## ADDENDUM NO. 3

To: All Plan Holders of Record and Interested Parties  
Project: Clinton County Administration Building - Addition & Alterations  
Project No.: 22072  
Issue Date: March 5<sup>th</sup>, 2024  
Bids Due: 2:00 PM, March 13, 2024

28 UPPER VESTIBULE TO LOWER VESTIBULE  
3/4" = 1'-0"

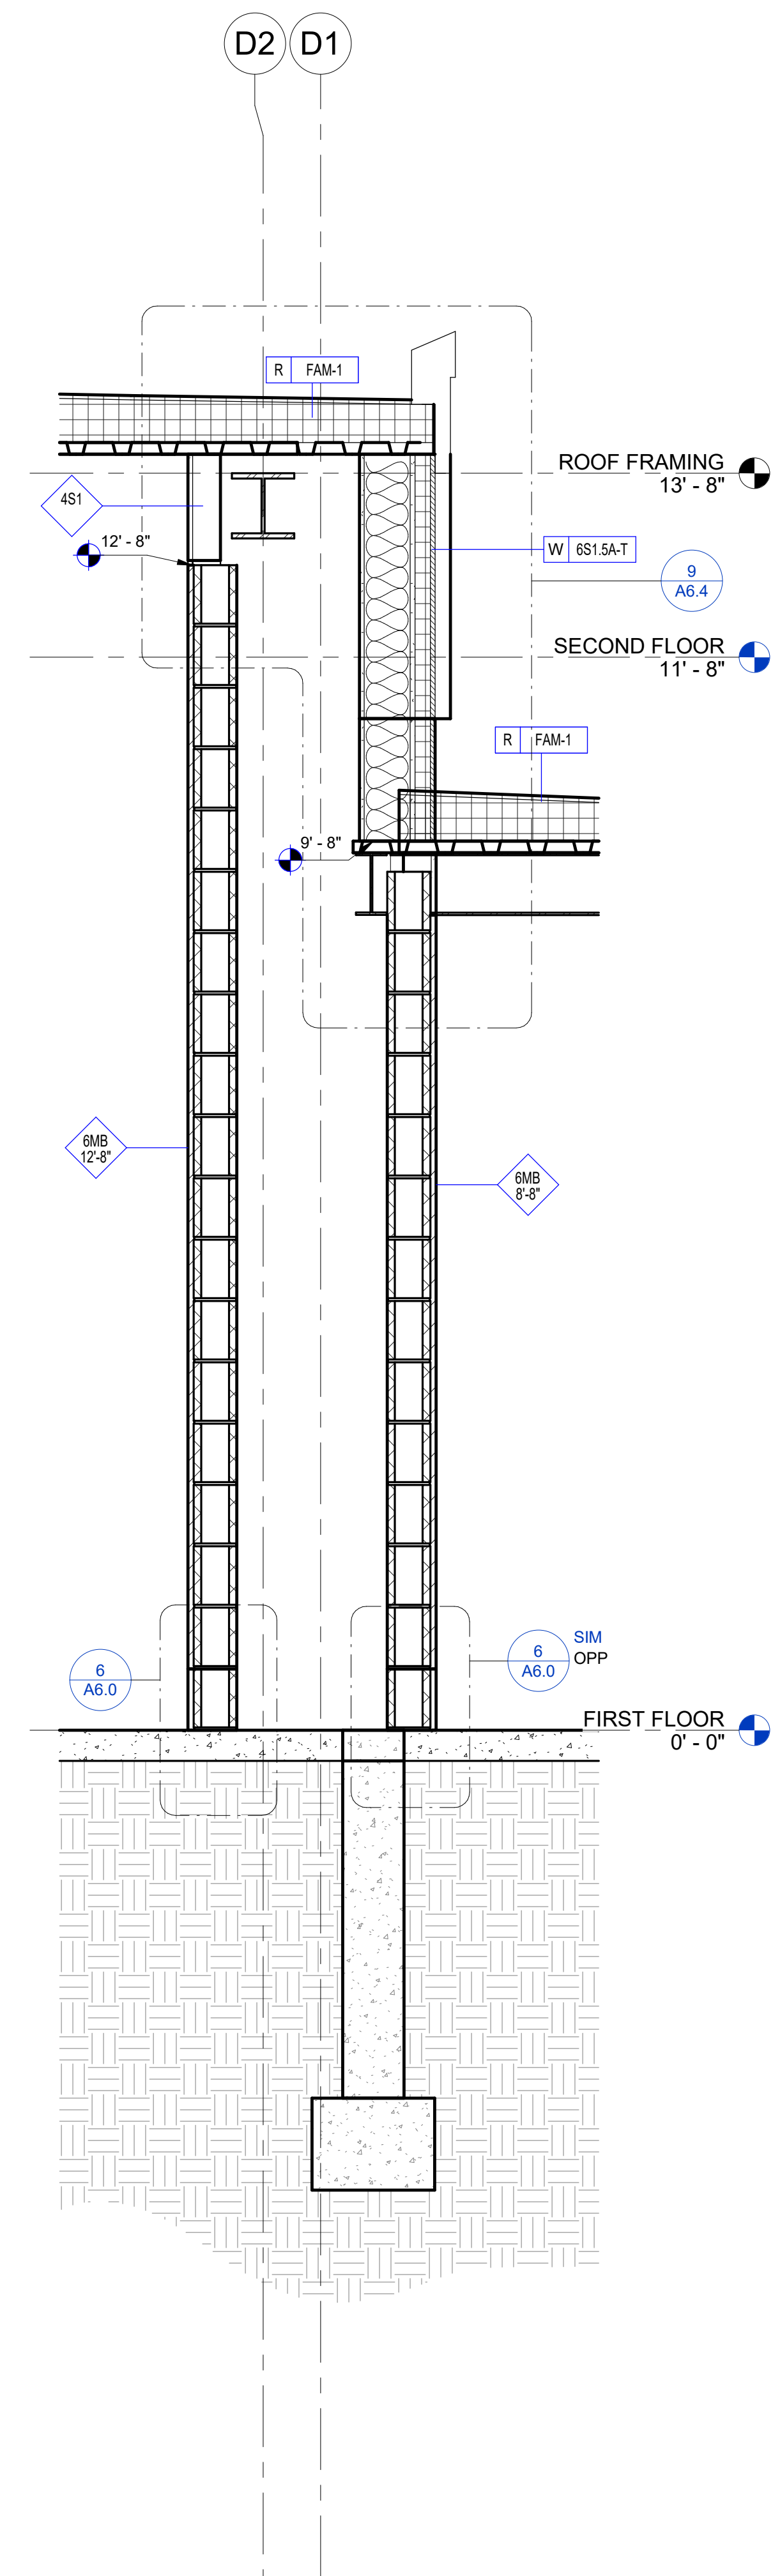
1. Wall Section #28 UPPER VESTIBULE TO LOWER VESTIBULE:
  - a. Revise the location of underslab insulation and grout covering. See re-issued sheet A5.4.

26 ENTRY WALL SECTION  
 3/4" = 1'-0"

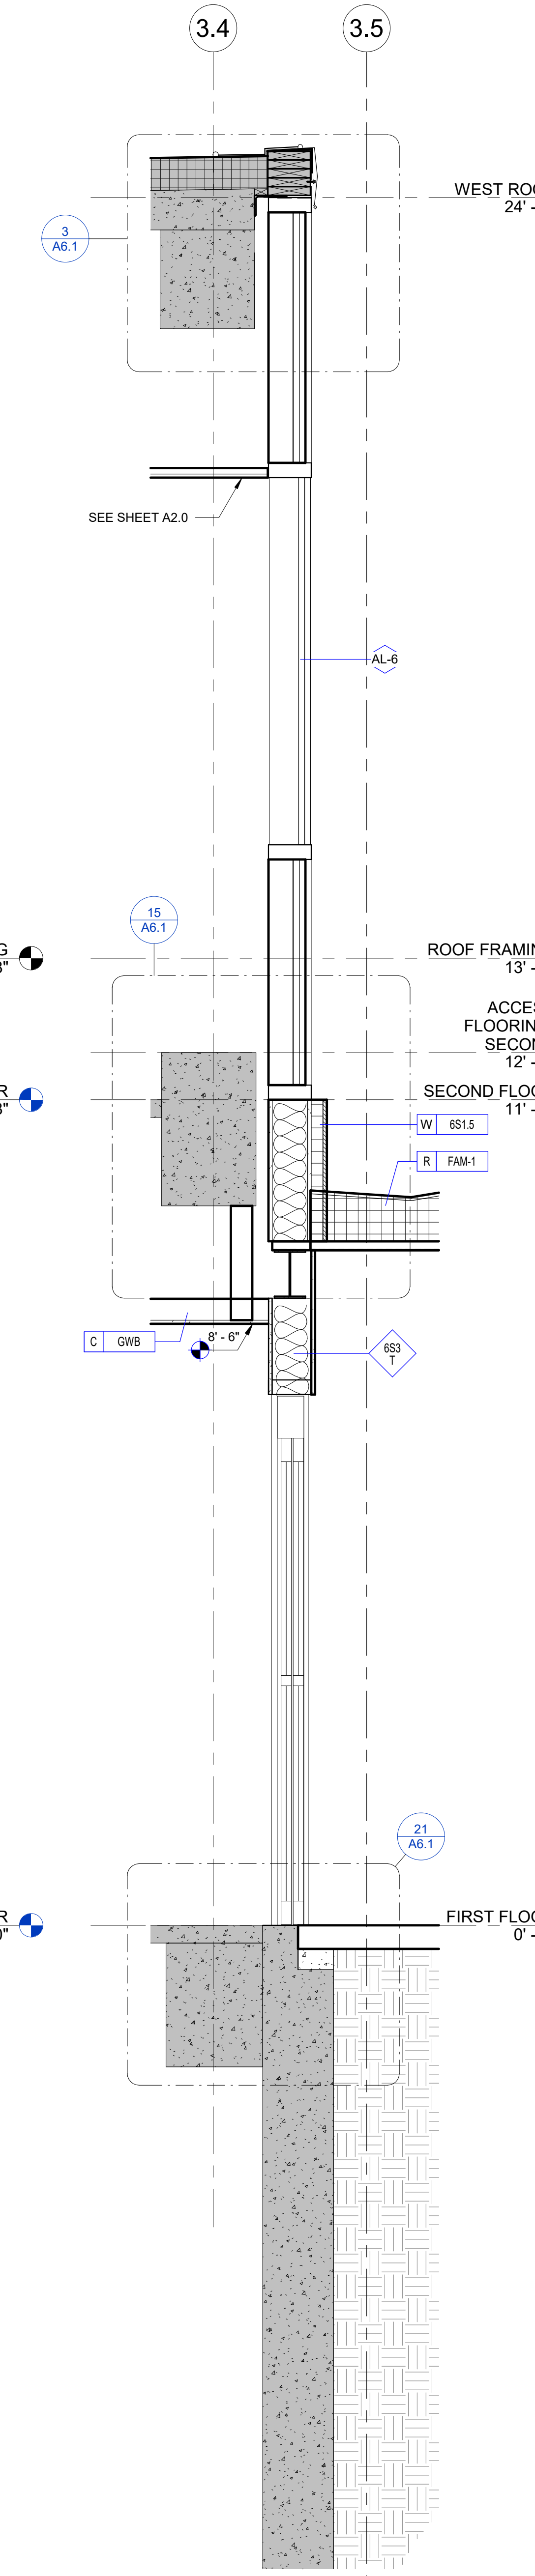
1. Wall Section #26 ENTRY WALL SECTION:
  - a. Revise the location of underslab insulation. See re-issued sheet A5.5.
2. Wall Section #28 ENTRY WALL AT COLUMN COVER:
  - a. Revise the location of underslab insulation. See re-issued sheet A5.5.
3. Wall Section #30 LOWER VESTIBULE CANOPY:
  - a. Revise the location of underslab insulation. See re-issued sheet A5.5.

7 TYP THRESHOLD AT AUTOMATIC SLIDING DOOR  
1 1/2\"/>

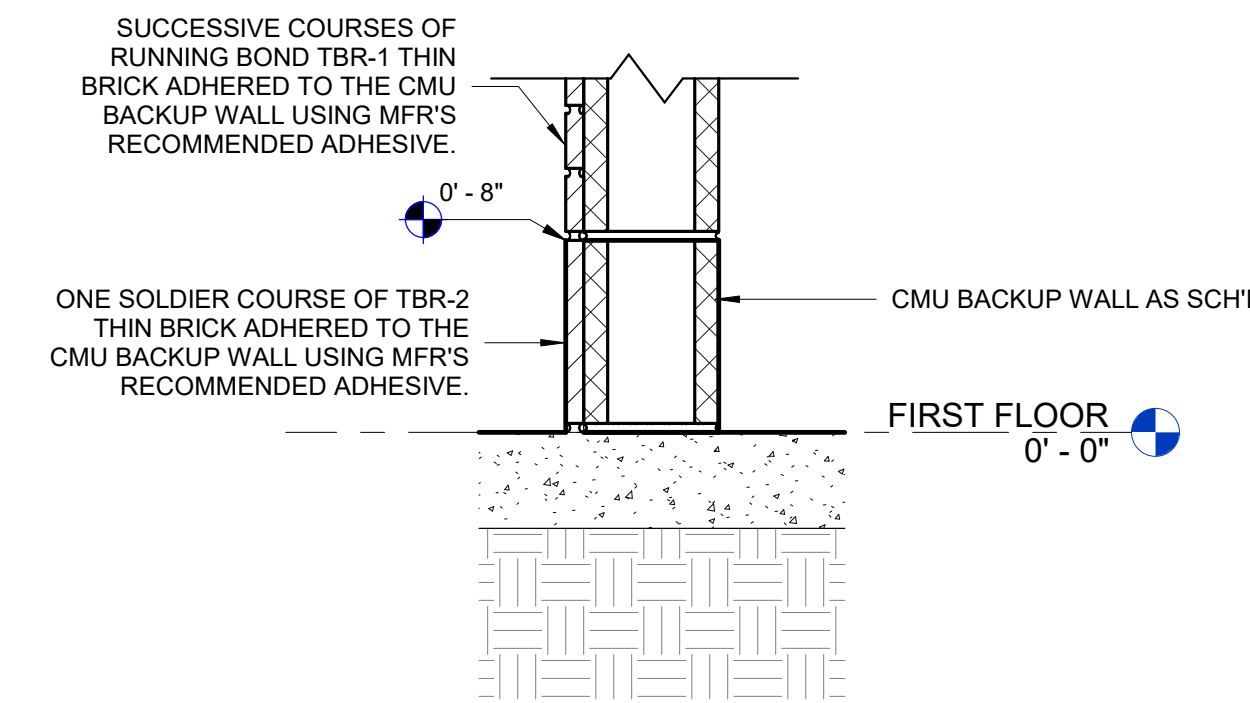
1. Detail #7 TYP THRESHOLD AT AUTOMATIC SLIDING DOOR:
  - a. Revise the location of underslab insulation, blocking, and the underslab vapor barrier termination. See re-issued sheet A6.0.

**3 TYPICAL 4'-0" WALL**  
3/4" = 1'-0"

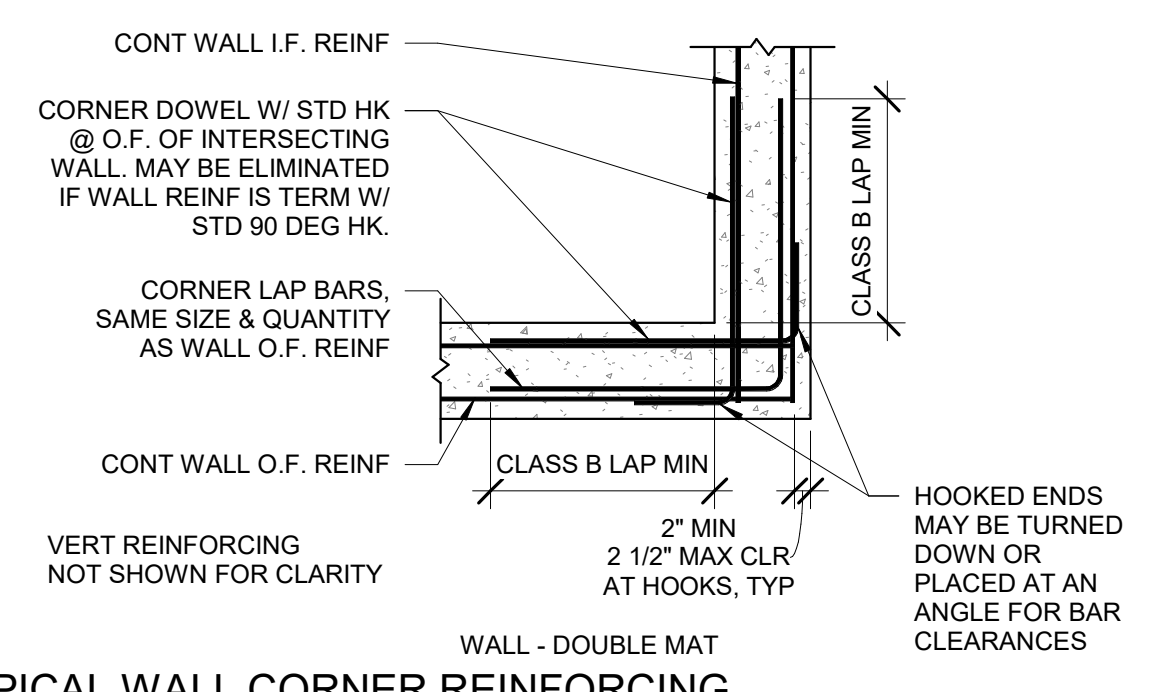
- d. Revise Foundation Plan Note #4 to add reference to insulation that will be around the perimeter of the slab. See re-issued sheet S1.2.
2. Detail #3 TYPICAL 4'-0" WALL

- a. Revise the location of underslab insulation. See re-issued sheet S1.2.
3. Detail #6 TYPICAL EXTERIOR PIER
  - a. Revise the location of underslab insulation. See re-issued sheet S1.2.

**6 TYPICAL EXTERIOR PIER**  
3/4" = 1'-0"

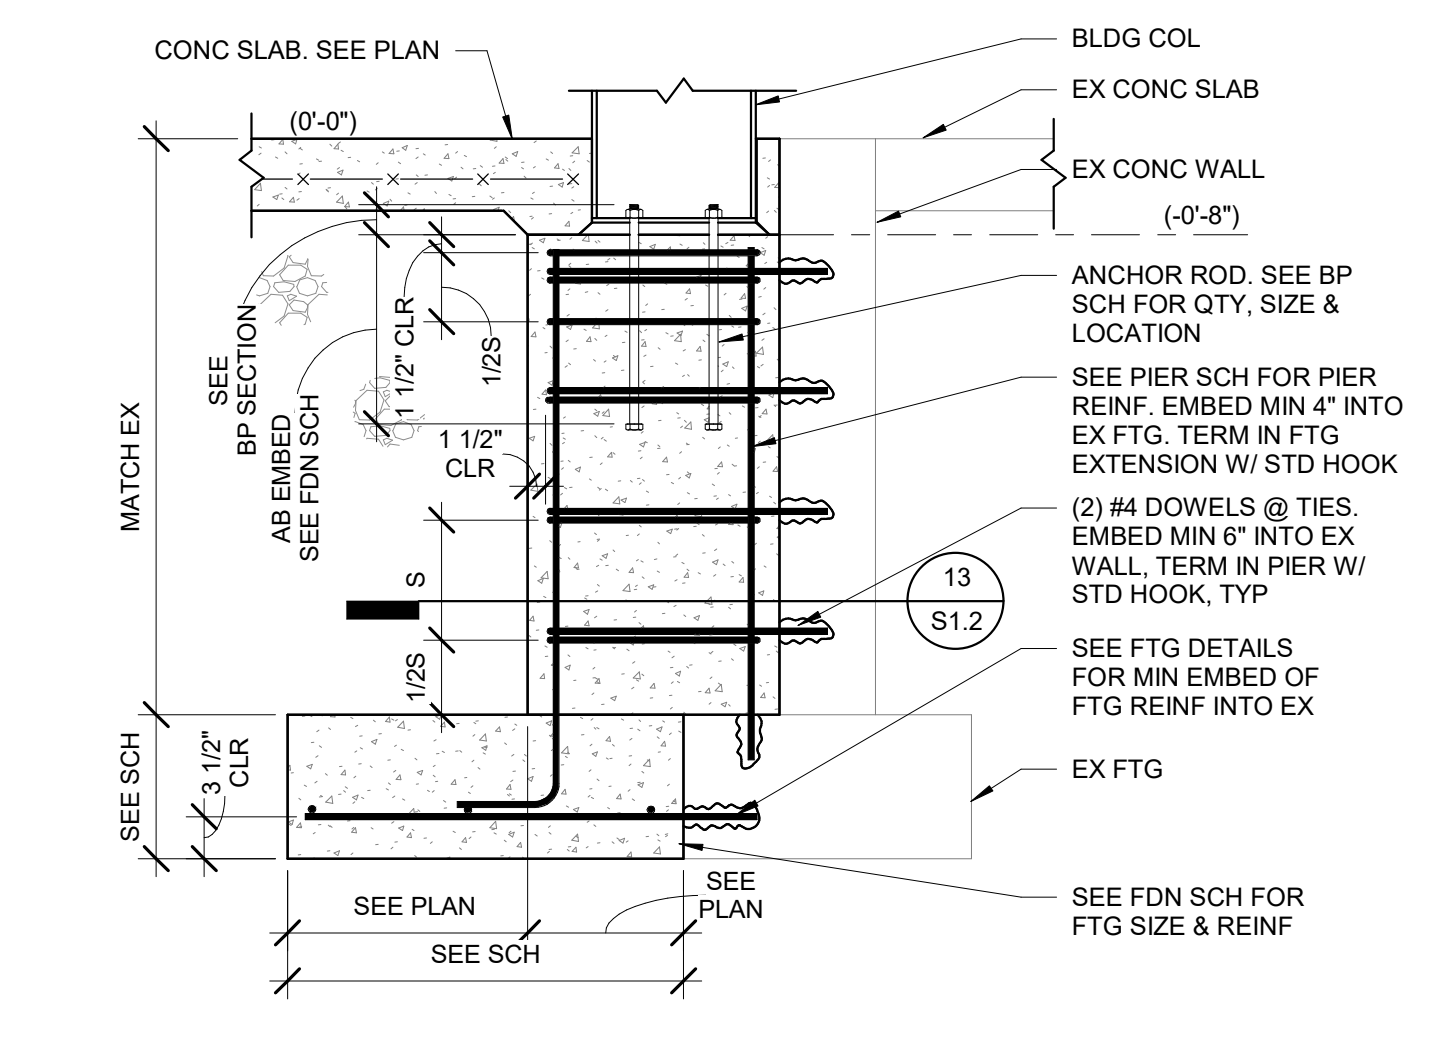
- b. Revise top of pier elevation and location of adjacent wall in detail. See re-issued sheet S1.2.
  - c. Revise column isolation joint requirements. See re-issued sheet S1.2.

**22 VESTIBULE FOUNDATION PLAN**  
3/8" = 1'-0"

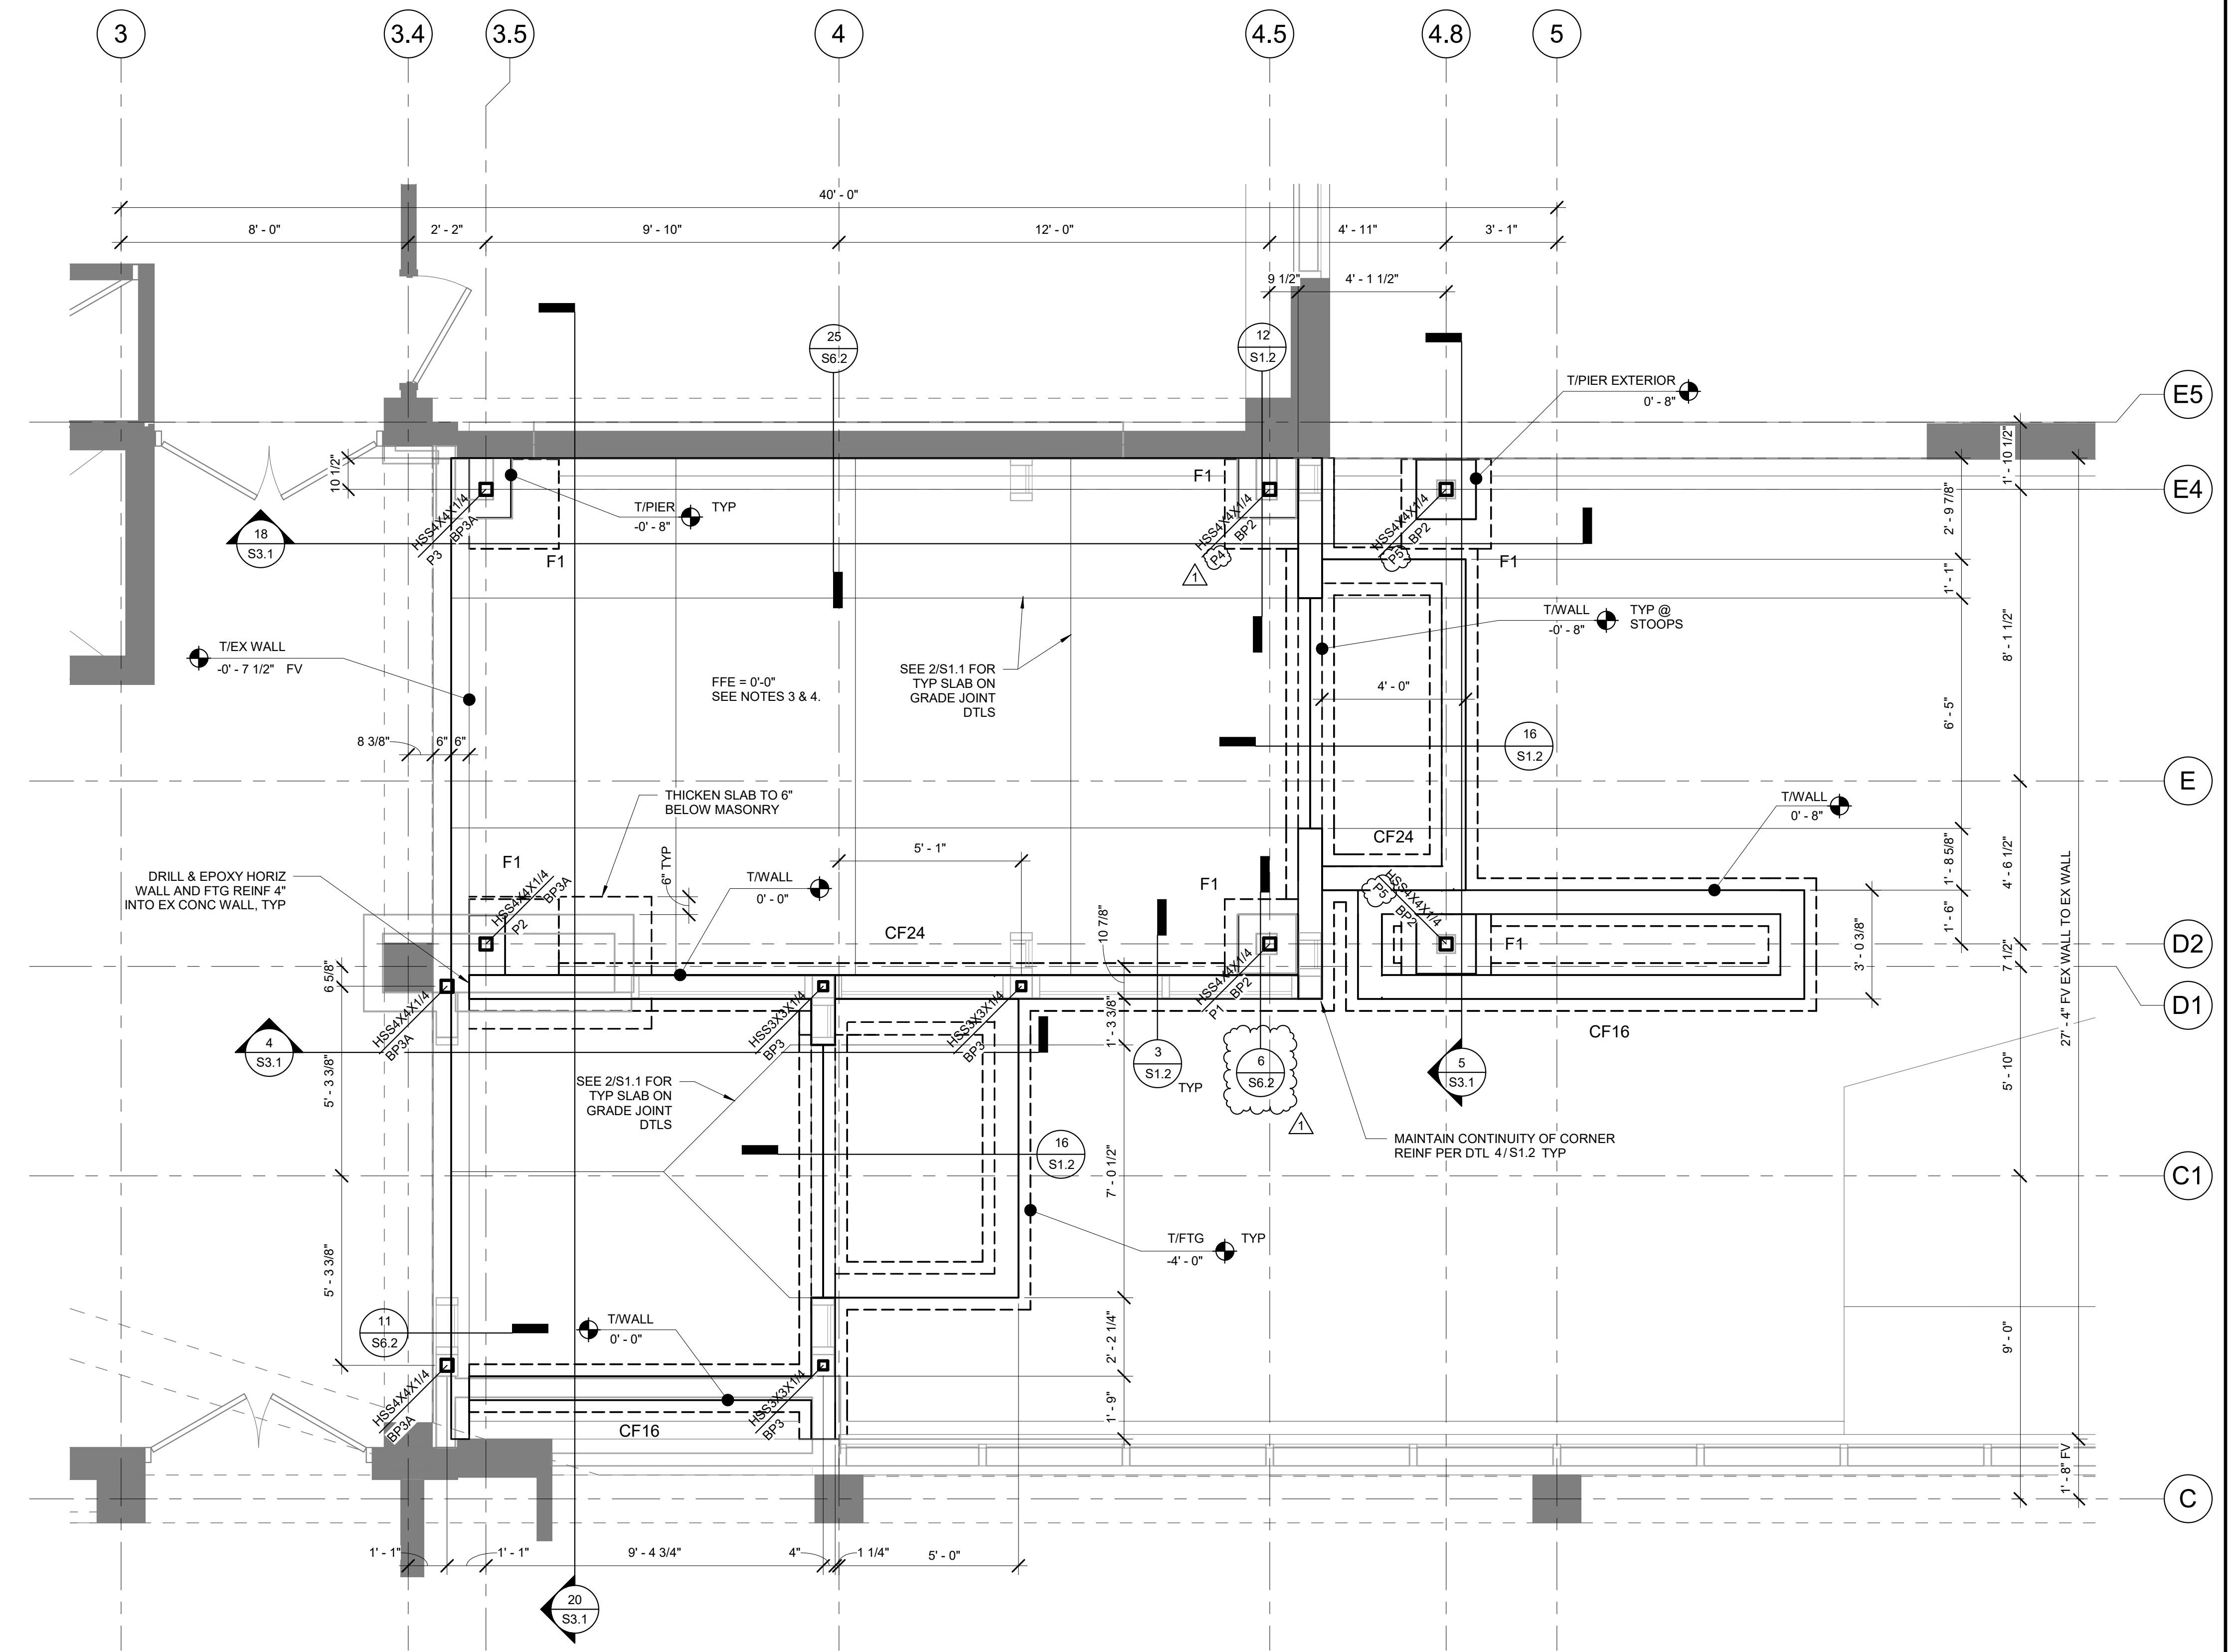
1. VESTIBULE FOUNDATION PLAN:
  - a. Add detail 6/S1.2 to plan. See re-issued sheet S1.2.
  - b. Revise clouded pier designations. See re-issued sheet S1.2.

- c. Revise Concrete Pier Schedule to clarify that pier sizes include wall dimensions, add pier sizes, and revise reinforcing. See re-issued sheet S1.2.
